Project	IEEE 802.16 Broadband Wireless Access Working Group < http://ieee802.org/16 >	
Title	Problems with Initial Ranging in OFDM PHY and a Solution	
Date Submitted	2005-01-26	
Source(s)	David A Castelow, Gavin Meakes, Eyal Verbin Airspan Communications, Cambridge House, Oxford Road, Uxbridge, UK Joël Demarty, Ambroise Popper SEQUANS Communications 101-103 bld Mc Donald, 75019 Paris, France Lei Wang Cygnus Multimedia Communications	Voice: +44 1895 467281 Fax: +44 1895 467202 mailto:dcastelow@airspan.com Voice: +33 1 44 89 48 07 mailto:joel@sequans.com mailto:lwang@cygnuscom.com
Re:	Supporting document for Comment to 802.16maint.	
Abstract	Changes required in order enabling good operation of 802.16 systems.	
Purpose	The document is intended for consideration within the comments resolution process.	
Notice	This document has been prepared to assist IEEE 802.16. It is offered as a basis for discussion and is not binding on the contributing individual(s) or organization(s). The material in this document is subject to change in form and content after further study. The contributor(s) reserve(s) the right to add, amend or withdraw material contained herein.

Problems with Initial Ranging

Figure 60 – Initial Ranging – SS (part 1)

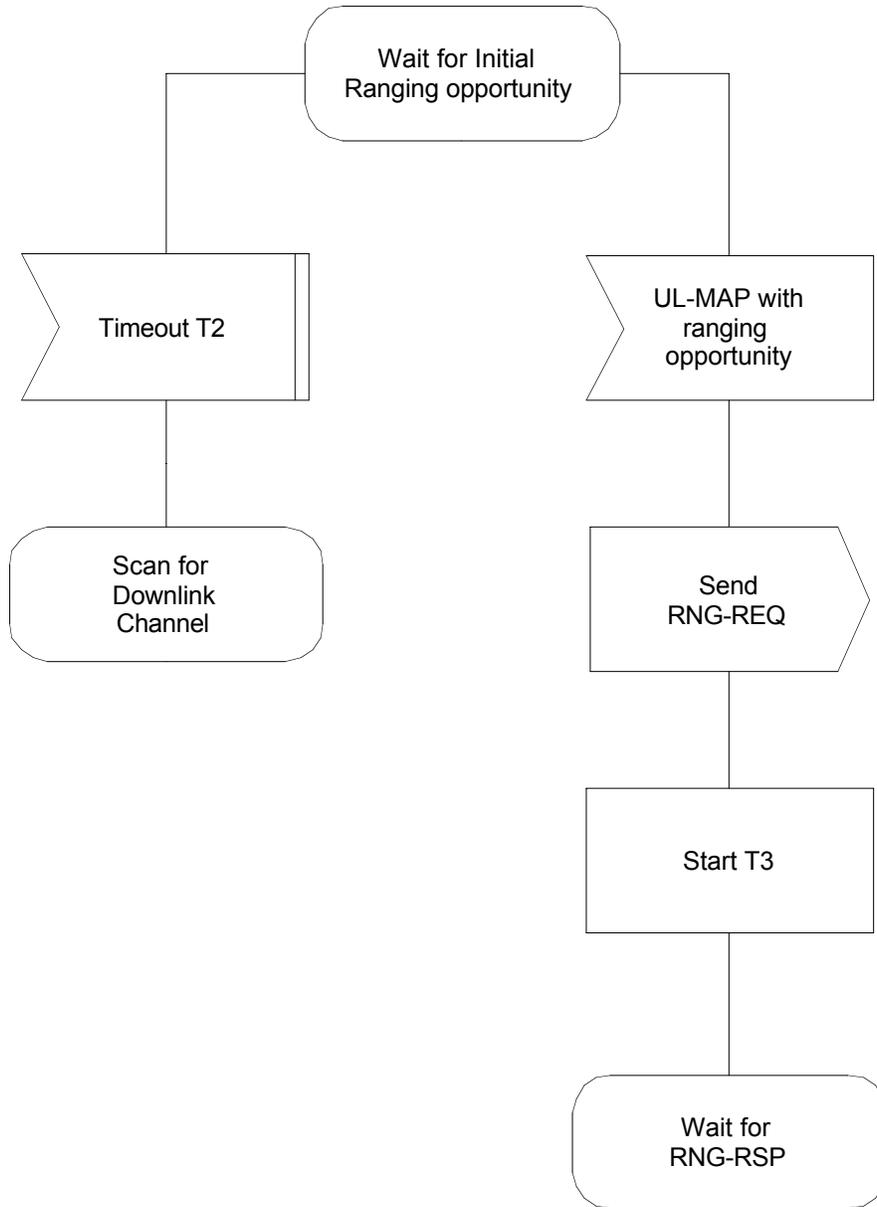
Test "Time to increase power?" does not seem to have a timer associated with it. It is in conflict with the text at [2, page 178, line 53 and page 179, line 6]. In these lines the power is required to be increased at each step. However, the change in power is not defined in the standard, and so the power step could be zero or changed dynamically. We suggest replacing the power step with an instruction to adjust the power.

[Replace Figure 61 with the following figure:]

NOTE 1 —Timeout T3 may occur because the RNG-REQs from multiple SSs collided. To avoid these modems repeating the loop in lockstep, a random backoff is required. This is a backoff over the ranging window specified in the UCD3 timeouts can also occur during multi-channel operation.

NOTE 2 — On a system with multiple uplink channels, the SS must attempt initial ranging on every suitable uplink channel before marking the downlink channel unusable and moving to the next available downlink channel.

Figure 85 – CDMA Initial Ranging – SS (part 1)

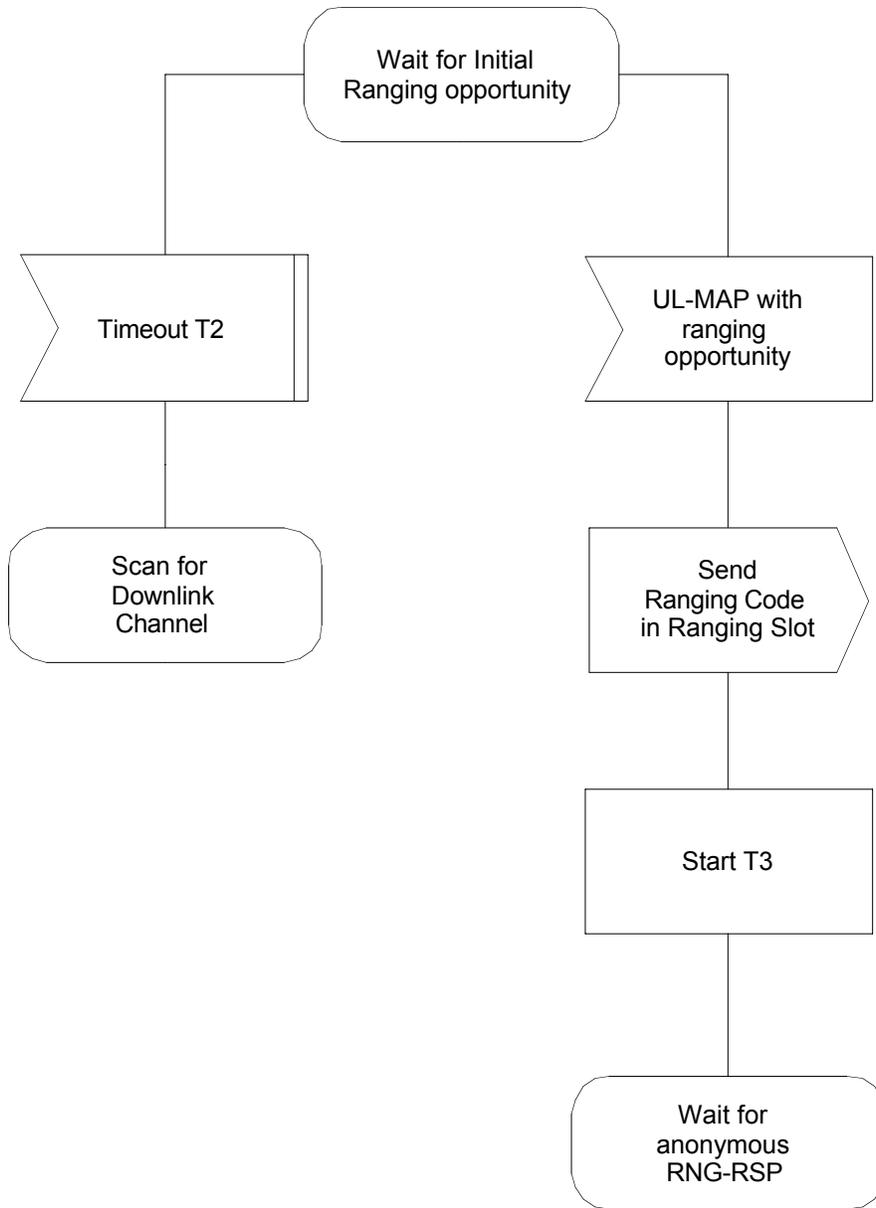
For OFDMA, the SS shall send a CDMA code at a power level below PTX_IR_MAX, measured at the antenna connector. If the SS does not receive a response, the SS shall send a new CDMA code at the next appropriate Initial Ranging transmission opportunity ~~at one step higher and adjust its~~ power level. If the SS receives a RNG-RSP message containing the parameters of the code it has transmitted and status continue, it shall consider the transmission attempt unsuccessful but implement the corrections specified in the RNG-RSP and issue another CDMA code after the appropriate backoff delay. If the SS receives an UL-MAP containing a CDMA allocation IE with the parameters of the code it has transmitted, it shall consider the RNG_RSP reception successful, and proceed to send a unicast RNG-REQ on the allocated BW. More details on this procedure can be found in 6.3.10.3.

NOTE 1 —Timeout T3 may occur because the CDMA codes or the RNG-REQ from multiple SSs collided. To avoid these modems repeating the loop in lockstep, a random backoff is required. This is a backoff over the ranging window specified in the UCD. T3 timeouts can also occur during multi-channel operation.

NOTE 2 — On a system with multiple uplink channels, the SS must attempt initial ranging on every suitable uplink channel before marking the downlink channel unusable and moving to the next available downlink channel.

Figure 210a – Subchannelized Initial Ranging – SS (part 1a)

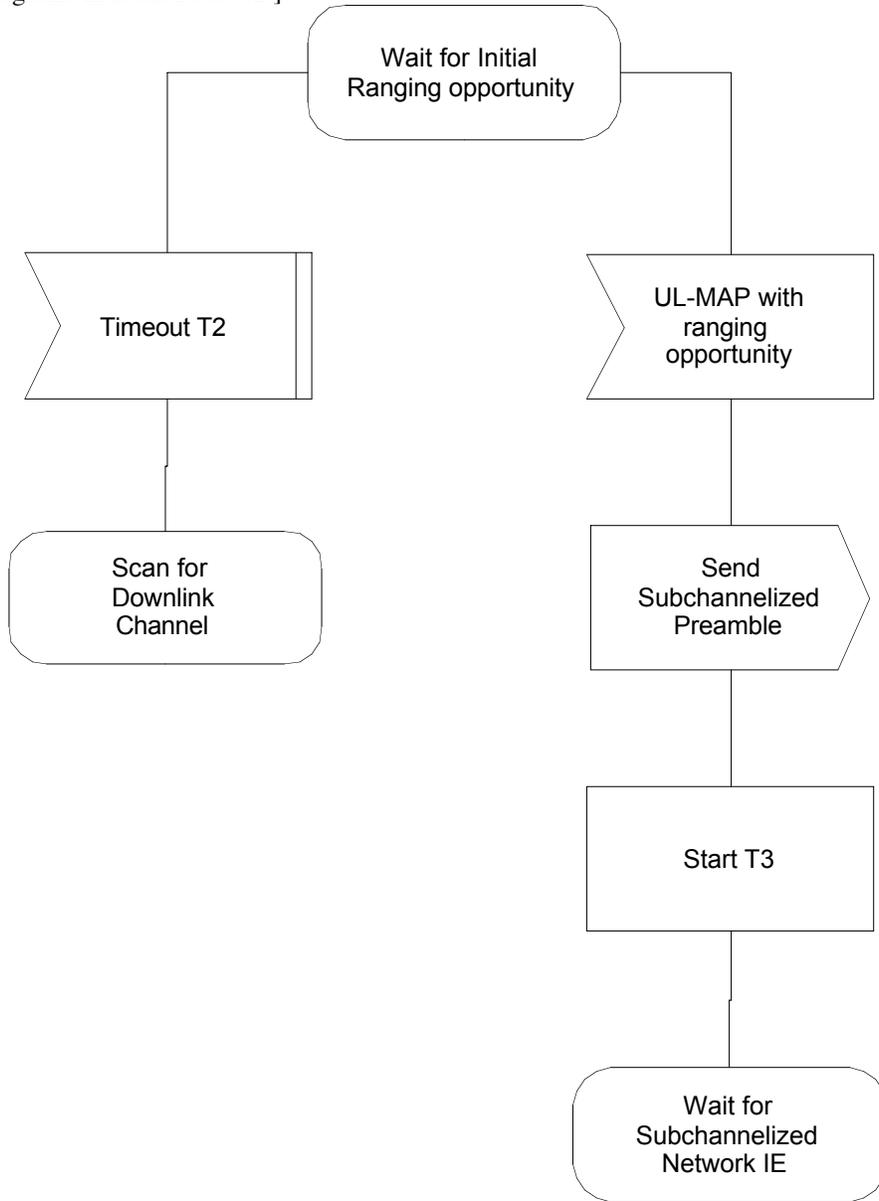
[Alter section 8.3.7.2 as follows, and insert STL diagrams describing behaviour of SS during sub-channelised initial ranging:]

~~SSs that compute their $P_{TX_IR_max}$ to exceed their maximum power level and SSs which have attempted initial ranging with the maximum power level using RNG-REQ may, if the BS supports subchannelization, an SS may attempt initial ranging in an initial ranging slot using the following burst format, as indicated in Figure 210a and Figure 210b:~~

[Include the following diagrams in section 8.3.7.2:]
